P 535221

**ON-SITE SEWAGE DISPOSAL SYSTEM  
 HOWARD COUNTY HEALTH DEPARTMENT  
 BUREAU OF ENVIRONMENTAL HEALTH**

SUBDIVISION: Hopkins Choice LOT NUMBER: 13

ADDRESS: 14075 Patterson Farm Court PROPERTY OWNER: Toll MD II LP

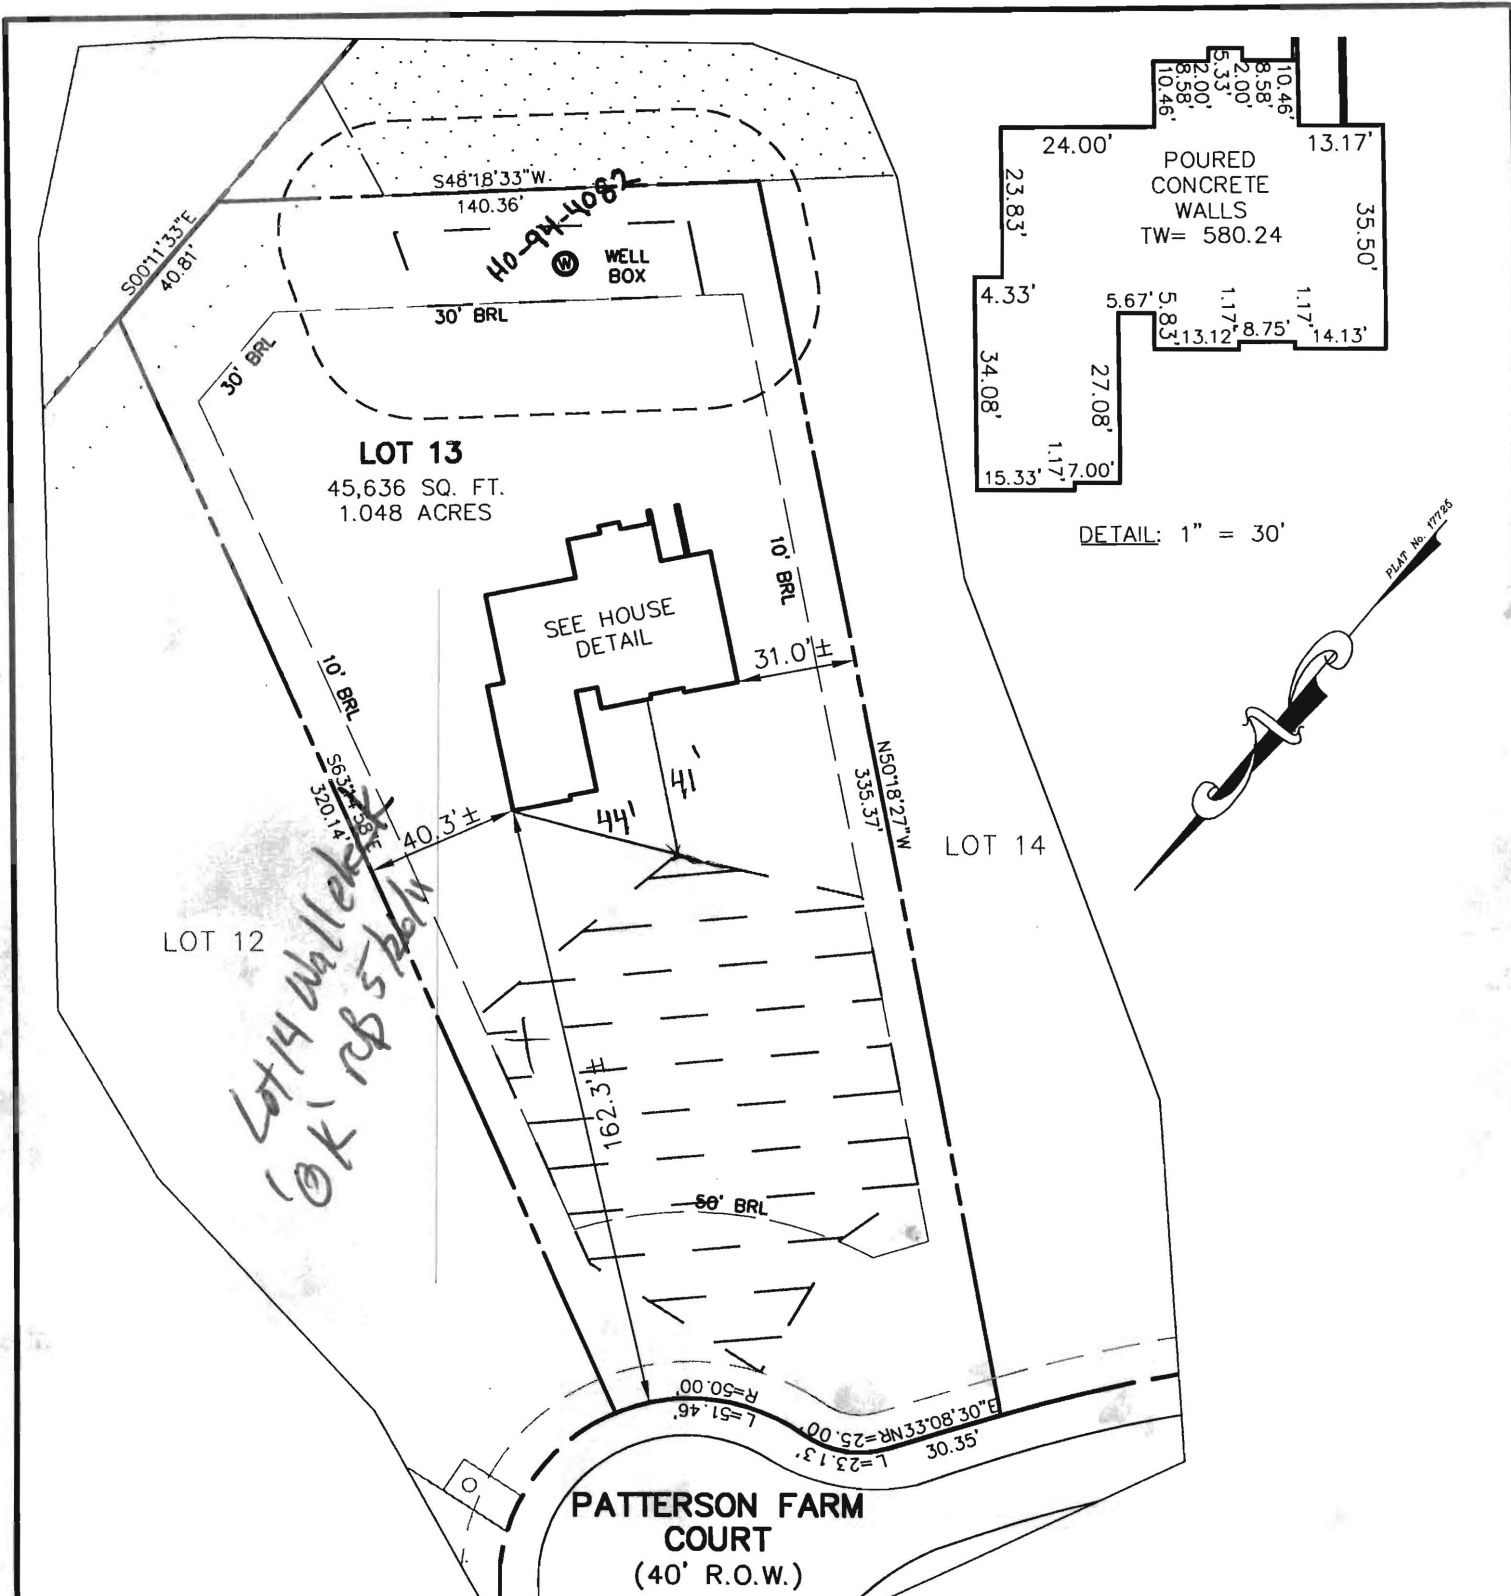
6/6/2011 Easement not staked. O.K. to set tank near where shown on B.P. plan (BB)

7/11/2011 Easement still not staked. (BB)

7/20/2011 Decided to move tank to opposite side of easement so that the tank and distribution box are away from the driveway. Unable to lay out trenches because there is too much stuff in the way. (BB)

7/22/2011 Laid out trenches. (BB)

7/26/2011 Need house connection and rear tank baffle. One trench is at least partially under the driveway. Told installer to fill driveway ends of trenches mostly with gravel to reduce/prevent settling. The trenches were supposed to end where the driveway started. (BB) 8/15/2011 House connection made. (BB)
